PARTS & SERVICE NEWS

REF NO.	AT01187A
DATE	Jan. 18, 2002

SUBJECT: MODIFICATION TO PREVENT INTERFERENCE OF HOSES AND HARNESSES FOR HYD. CIRCUIT ON HM400-1

PURPOSE: To introduce modification procedures to prevent interference of the hydraulic circuit hoses and the harnesses on HM400-1 dump trucks

Fig. 1

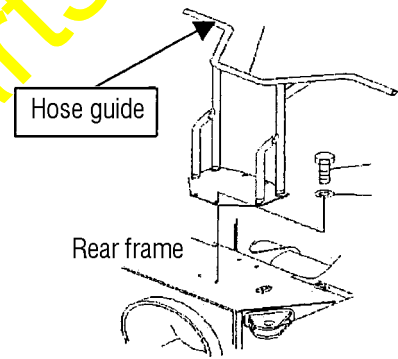
- 1) Remove the hose guide installed to the front section of the rear frame. (Refer to Fig. 1.)
- 2) Cut the end of the hose guide. (Refer to Fig. 2.)
- 3) Weld the pipe (56B-99-19560) to connect to the top end of the cut pipe. (Refer to Fig. 3.)
- 4) Finish the welded section to smooth surfaces by use of a grinder.
- 5) Make touch up by Black Gray paint color.
- 6) Install the hose guide to the rear frame

Fig. 4.

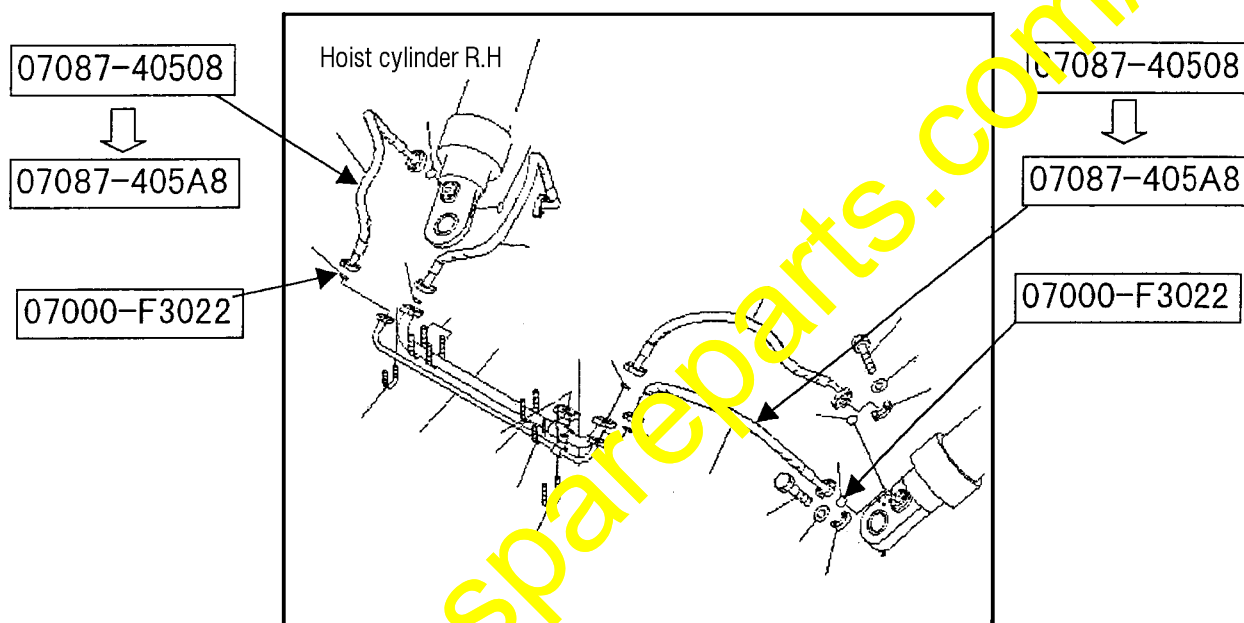
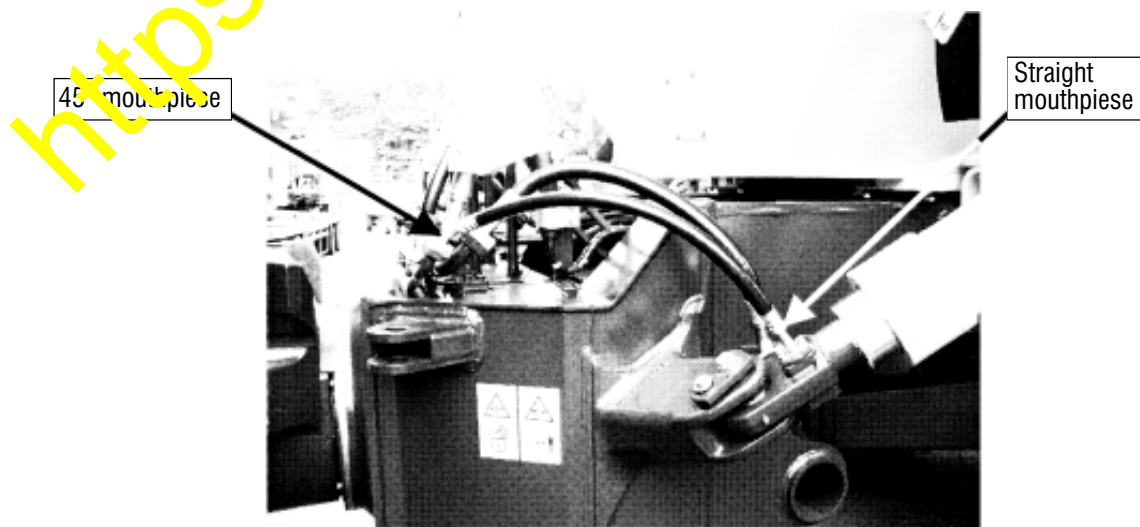
- 1) Disconnect the hoist cylinder return side hose (the thinner hose). (Refer to Fig. 4.)
- 2) Replace the above hose with the hose (07087-405A8) prepared for the modification.
<L = 800 mm → 850 mm>
Replace the O-ring (07000-F3022) with the new part at the same time.

Fig. 5

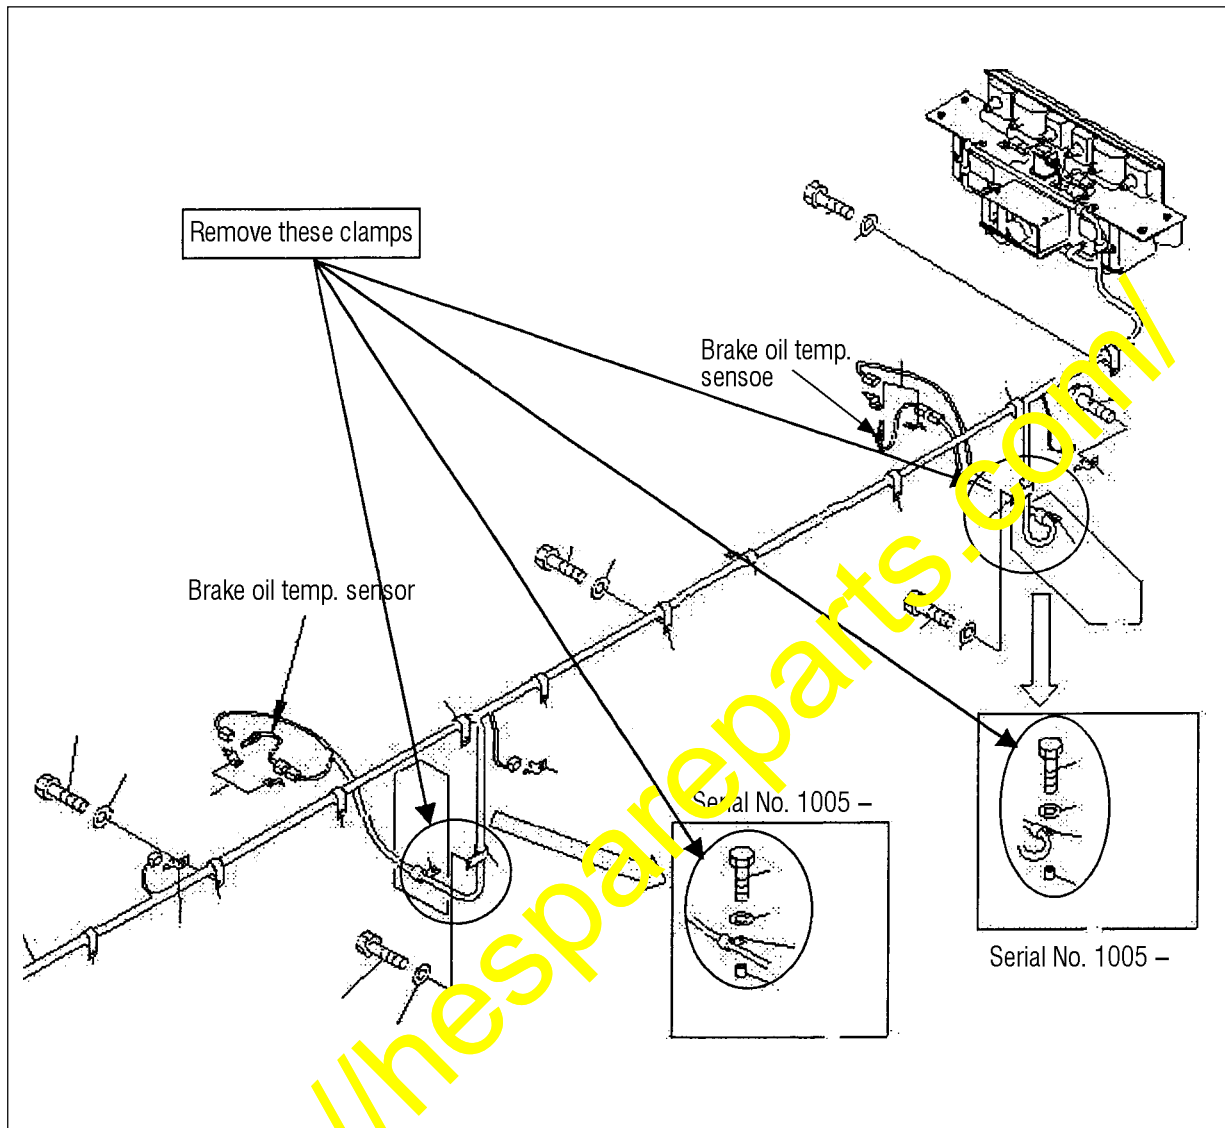
- 1) Remove the existing clamps. (Refer to Fig. 5.)

Fig. 6

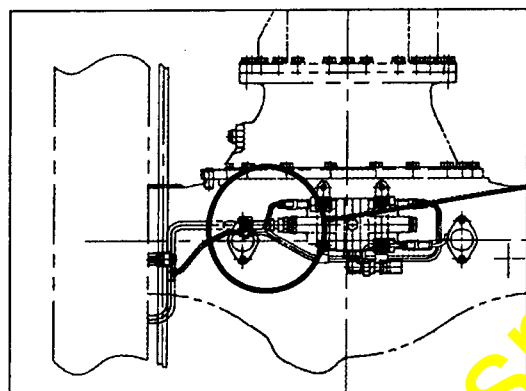
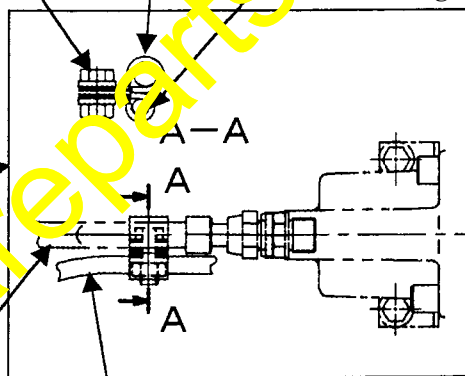
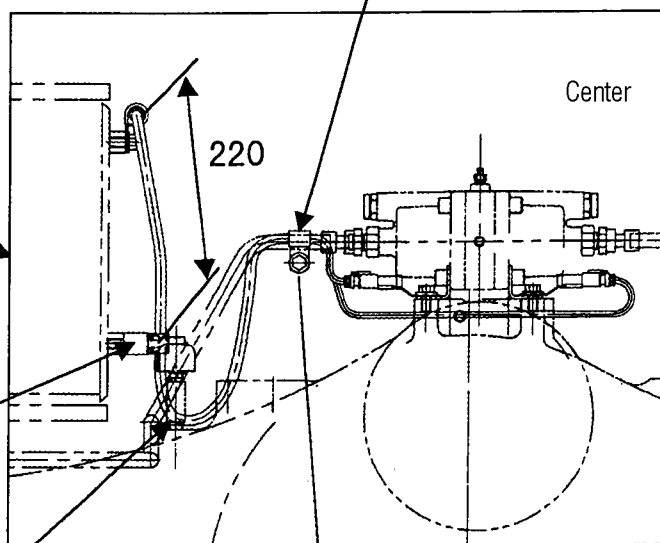
- 2) As for the axle side, clamp the harness together with the slack adjuster piping by the clips. (Refer to the Cross-Section A-A.)

- 3) As for the frame side, clamp the harness by use of the spacer.

Slack adjuster piping Harness Clamp it together with the adjuster piping

Slacken it in this section

Clamp at the branching position

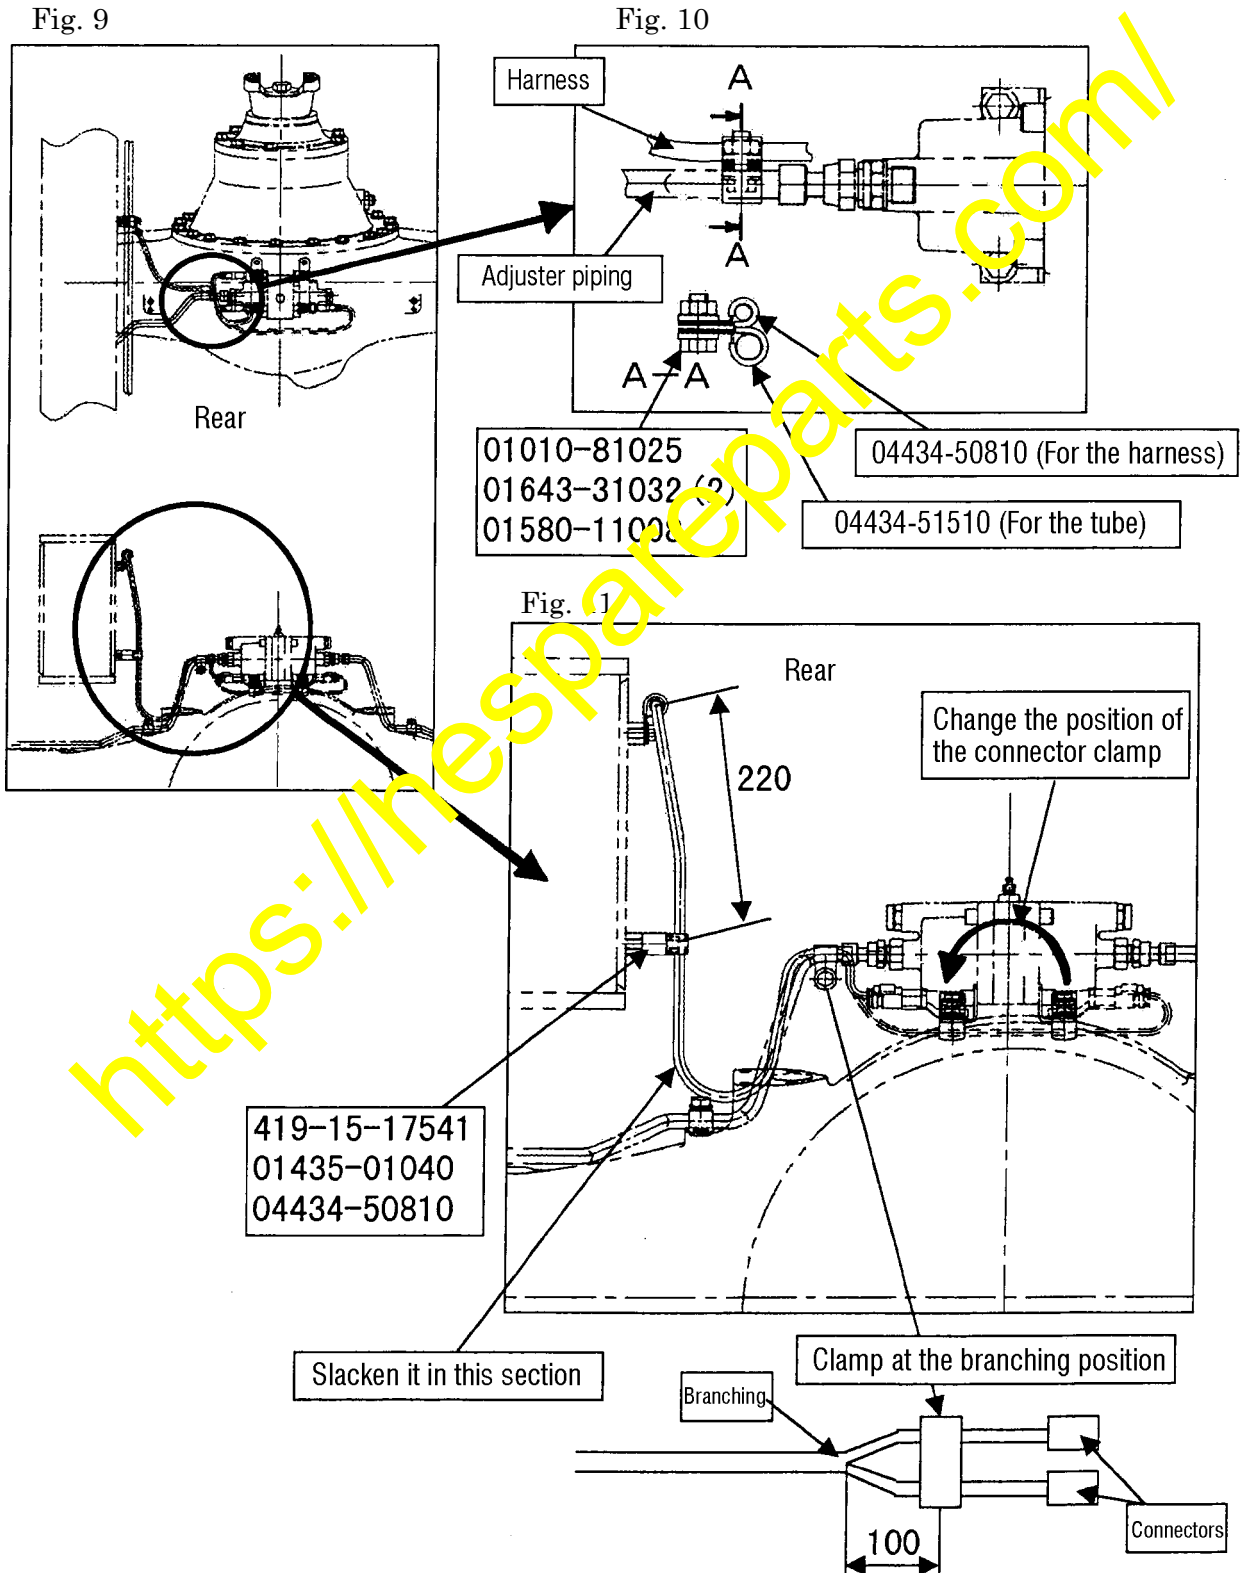
- 4) As for the axle side, clamp the harness together with the slack adjuster piping by the clips. (Refer to the Cross-Section A-A.)

- 5) As for the frame side, clamp it by use of the spacer.

Fig. 12

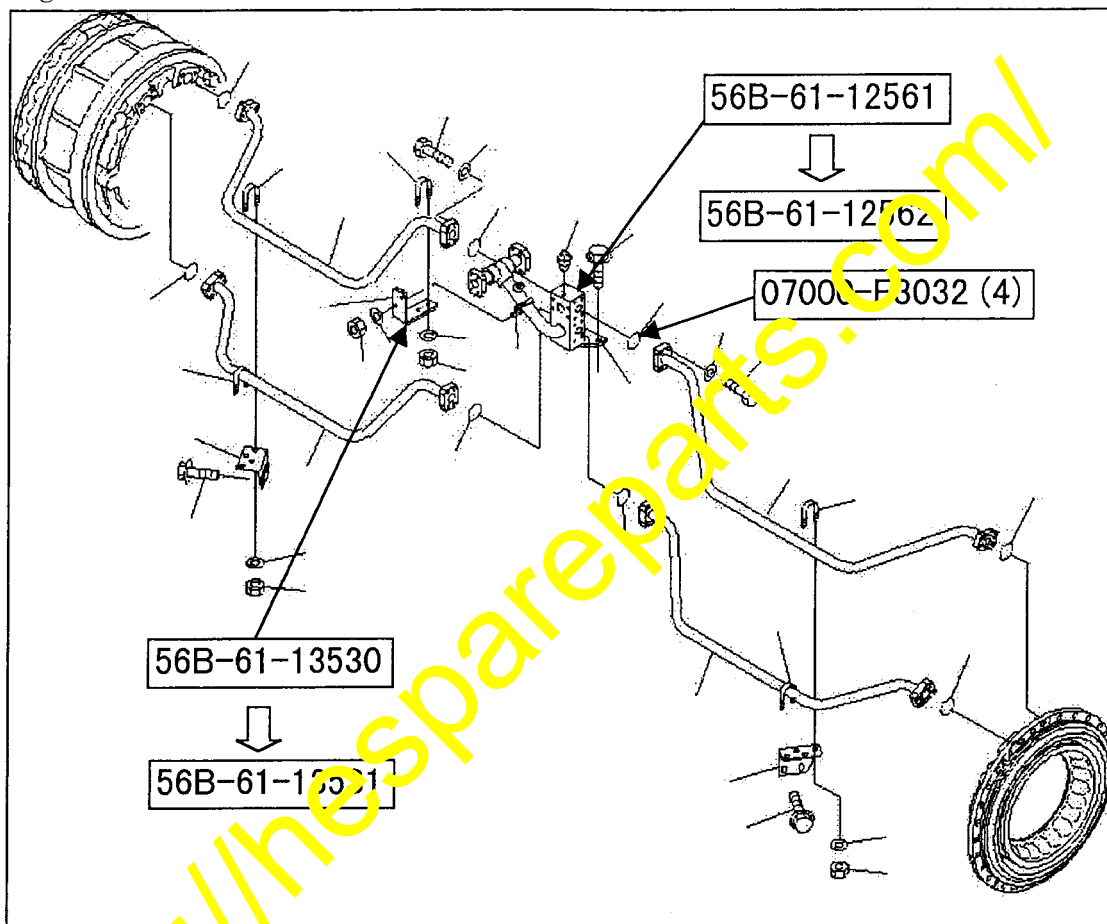
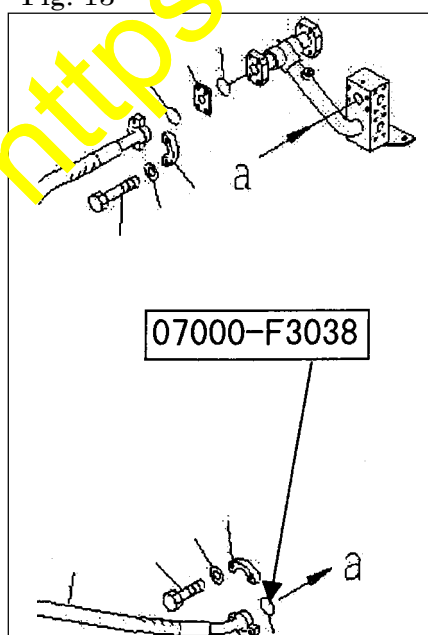
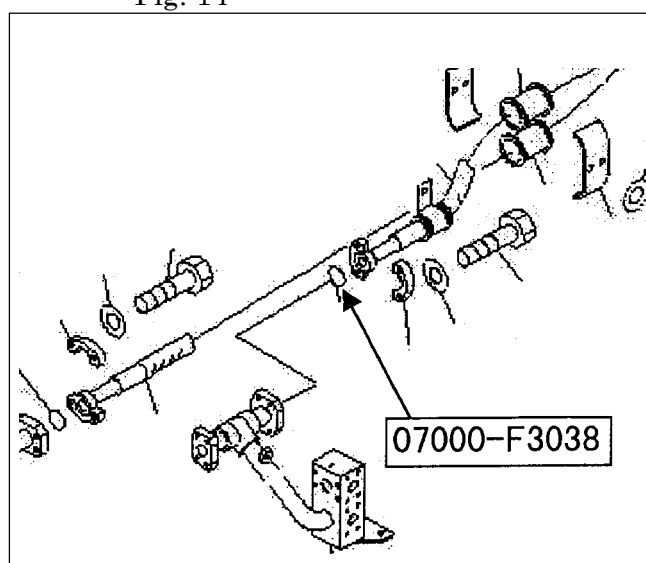
4-5. Modification procedures to prevent interference of the retarder cooling hose (Refer to Fig. 12, Fig. 13 and Fig. 14.)

- 1) Replace the block (56B-61-12561) with the block (56B-61-12562) developed for the modification.
- 2) Replace the plate (56B-61-13530) with the plate (56B-61-13531) developed for the modification.

Replace the O-rings (07000-F3032) and (07000-F3038) with new parts at the same time.

Fig. 15

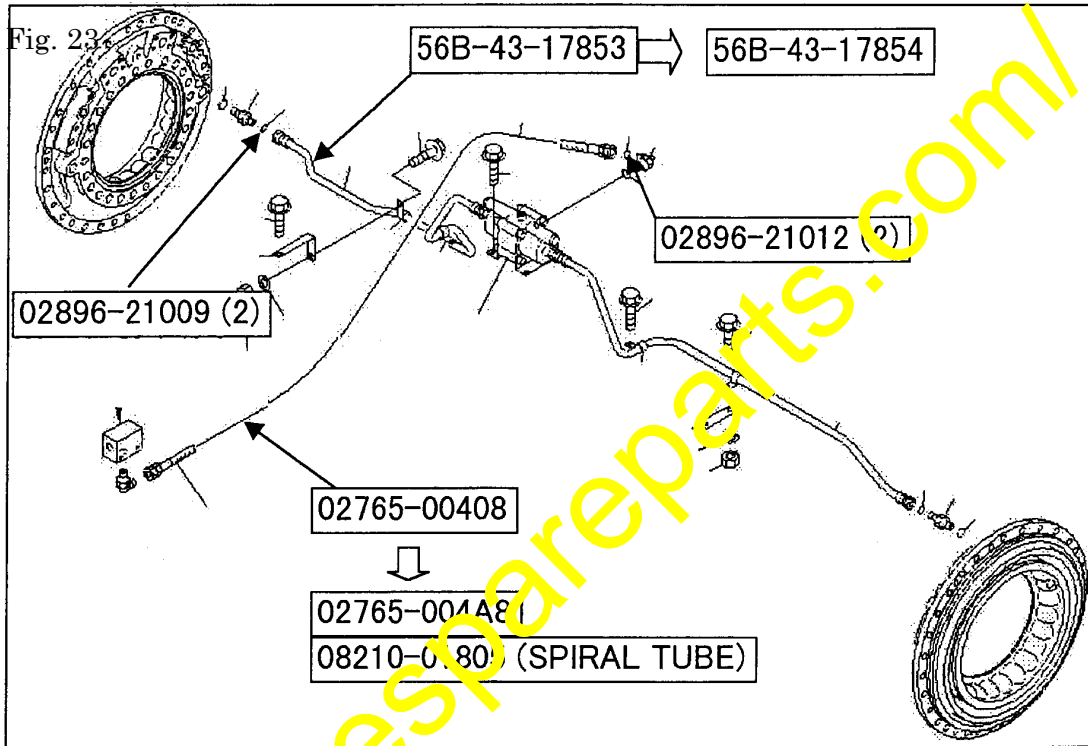
- 1) Replace the slack adjuster outlet tube (56B-43-17853) of the center axle with the tube (56B-43-17854) developed for the modification.
 - 2) Replace the slack adjuster inlet tube (02765-00408) of the center axle with the hose (02765-004A8) developed for the modification.
 - 3) Replace the slack adjuster inlet tube (02765-00408) of the rear axle with the hose (02765-004A8) developed for the modification.
- Replace the O-rings (02896-21009) and (02896-21012) with new parts at the same time.

Fig. 17

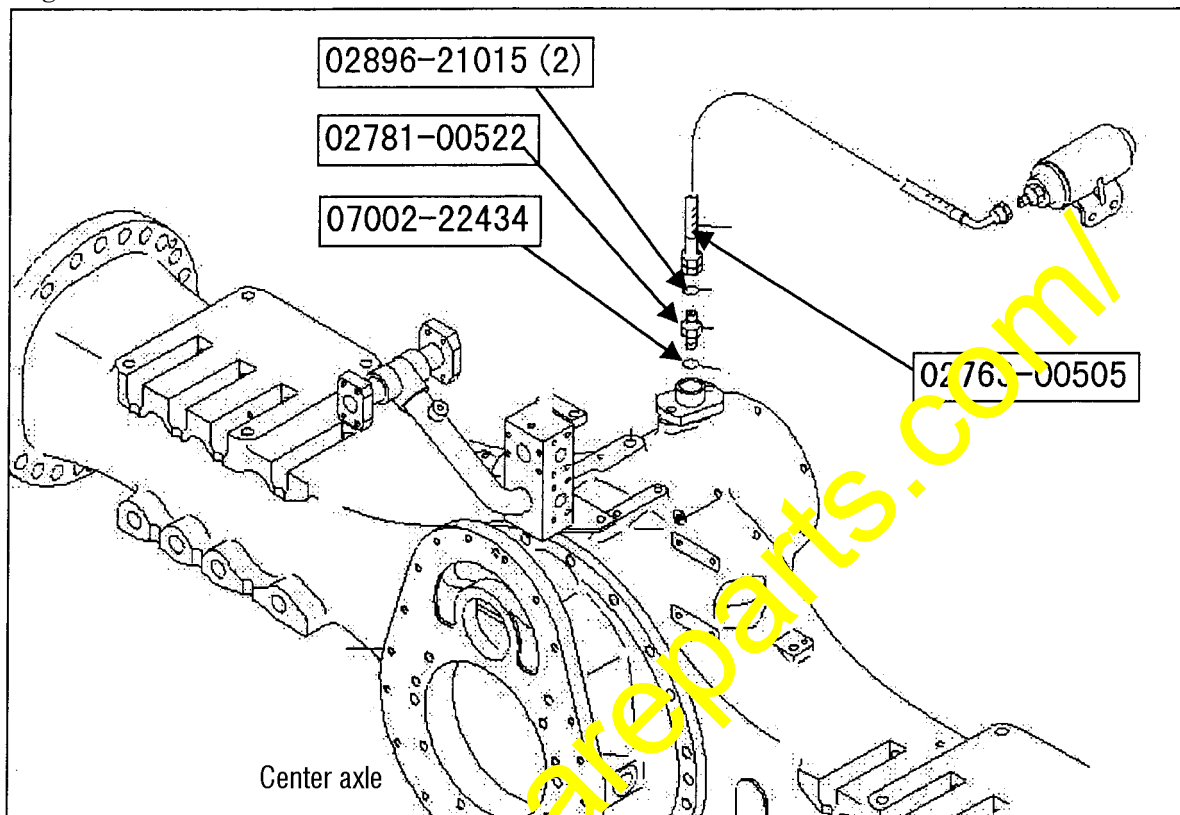
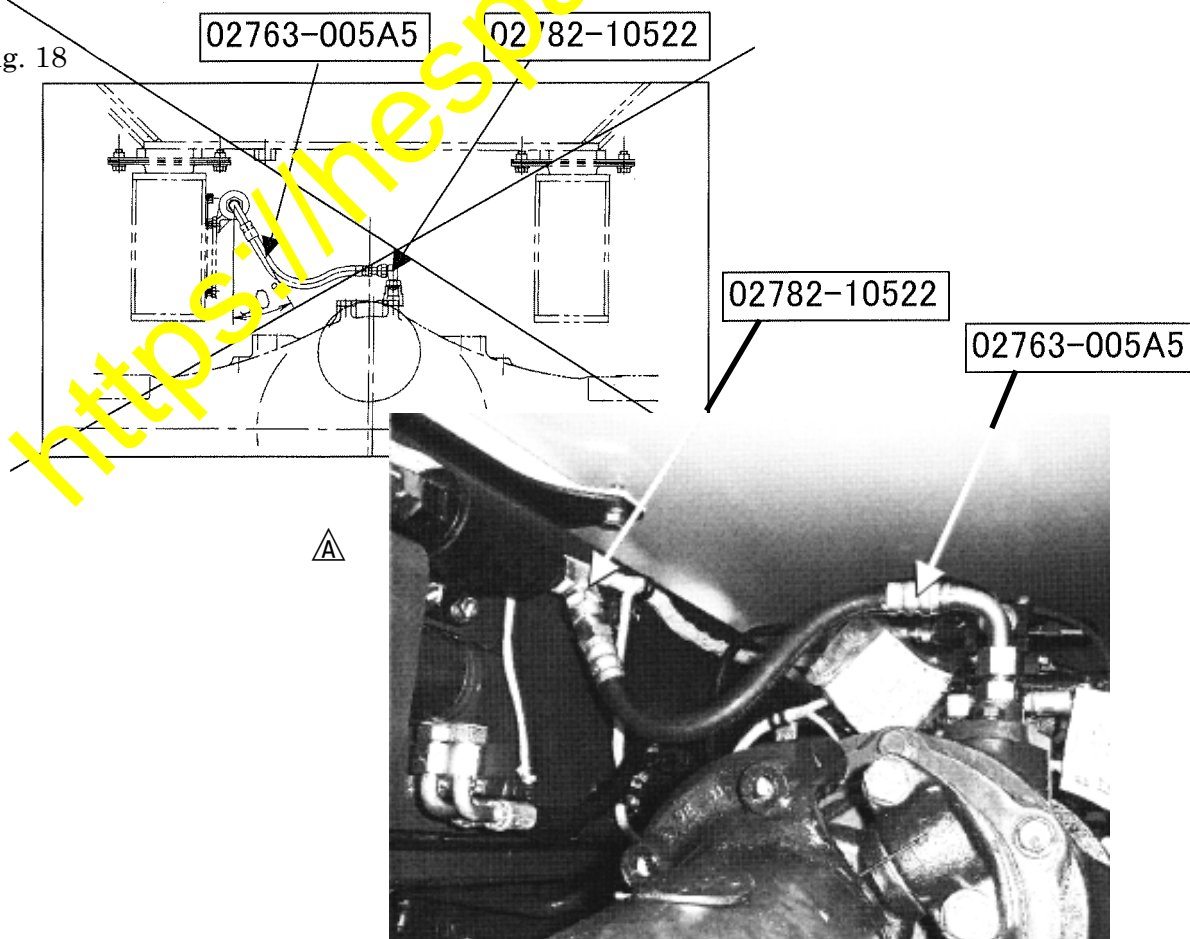
- 4-7. Modification procedures for the center axle dif. lock hose (Refer to Fig. 17 and Fig. 18.)
- 1) Replace the union (02781-00522) with the elbow (02782-10522).
 - 2) Replace the hose (02763-00505) with the hose (02763-005A5). Replace the O-rings (07002-22434) and (02896-21015) with new parts at the same time.
